IN THE MATTER                      of an application for a Private Plan Change – Plan  
Change 84 (PC84)

**Evidence of Amitabh (Amit) Arthanari on behalf of Berggren Trustee Co. Limited  
C/- Maria Berggren**

**(Traffic Engineering)**

**Dated 06 May 2024**

Figure 3: Draft Structure Plan PC84<sup>5</sup>

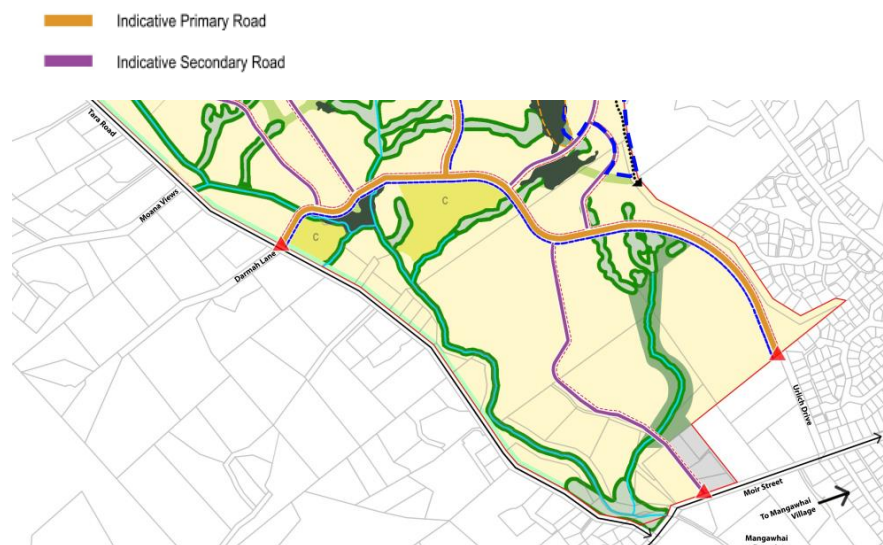
4.11 As shown in Figure 3 above, a primary road connection to Ulrich Drive and a secondary road connection through a JOAL that provides access to a number of properties in the southern end of the plan change area.

- 4.12 With regard to the 20-meter-wide primary road connection (orange line), it is understood that this road connection is proposed through the Mangawhai Church Trust Land and is opposed by the Trust. Therefore, there is a real possibility that the only proposed primary road connection to Moir Street may not be realised.

- 4.13 The 16 metres wide secondary (purple) road roughly follows the existing alignment of the JOAL for properties at 106 Moir Street. This accessway is currently single width for the majority of the way, is typically steep and narrow. The ability to form a suitably wide road reserve through this alignment, although possible is likely to require substantive retaining, civil and earthworks to achieve, including additional land acquisition as the current legal width of the JOAL seems to vary between 5.5 metres and 10-metres (measured off KDC Maps). For these reasons (cost, technical construction and land ownership) it is a real possibility that this secondary road connection may also not eventuate.

- 4.14 On this basis, there is a distinct possibility that a number of the southern sites would not be suitably connected to Moir Street and would not be able to be developed until potential connections over my client's land, through to Tara Road, could be provided. Again, such connections rely on crossing other people's land and may therefore not be able to be realised. Should an appropriate north-south primary road link not be provided; is possible that various disparate access roads and JOALS would be formed to service individual lots.

- 4.15 It is therefore recommended that an alternate southern primary road alignment is identified by the structure plan that would enable some degree of flexibility in achieving the intended outcomes of the structure plan transport policies and objectives.

Figure 4: Route B – Alternative Primary Road Connection to Moir Street

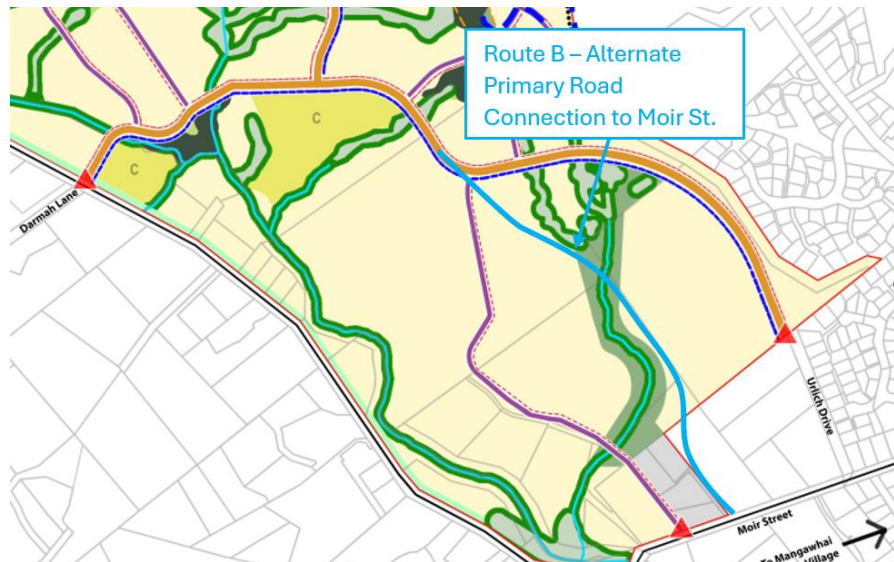
4.17 The suggested alternate connection has been recommended on the following basis:

- (a) the suggested primary road would be formed through Council owned land, providing a level of control/flexibility in achieving crucial connectivity outcomes for the plan change area.
- (b) The proposed alternate access road would intersect with Moir Street at a location where there is a relatively flat and straight road alignment, with good visibility in both directions.
- (c) Based on a review of contour information and engineering information provided in the application material and communication with MS Farley from Hutchinson Consulting Engineers (Civil), Topography in this area is understood to be relatively better suited to achieving appropriate longitudinal gradients.
- (d) Based on Communication with Mr Klassen, the proposed alternate primary road would limit exposure to known wetland features.

Figure 5: Northern Primary Road Connection for Allot 427

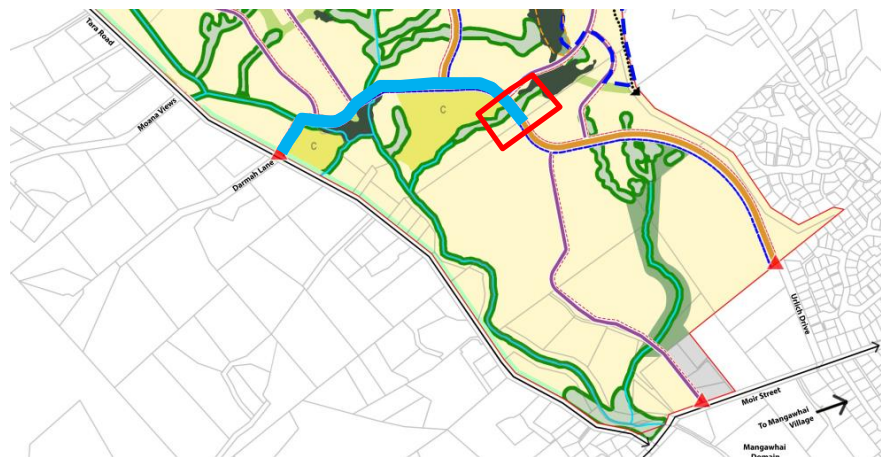
- 4.18 Should roading connection to Moir Street not eventuate, this would also mean that the sole connection for the southern lots to the primary road network would be via a connection approximately mid-way along the northern boundary to ALLOT 247 PSH OF MANGAWHAI (Allot 247).
- 4.19 Should this northern link not be extended to meet the boundary of my client's land, then there is a possibility that no viable primary road connection is formed to Allot 247 and subsequently other southern sites that would be reliant on this connection being made. See figure below:

- 4.20 As explained above, such a connection has to be a stated prerequisite for any development. The ability to connect the southern sites in the Plan Change area and the ability to create a north south connection through to Moir Street are fundamental to appropriately managing the transportation effects.
- 4.21 The Development Area provisions need to be amended to create this certainty and at a minimum, require the connection to be provided from Moir Street to Tara Road (Primary Road 2) at the first stage of development for housing and / or subdivision to ensure network connectivity and resilience.
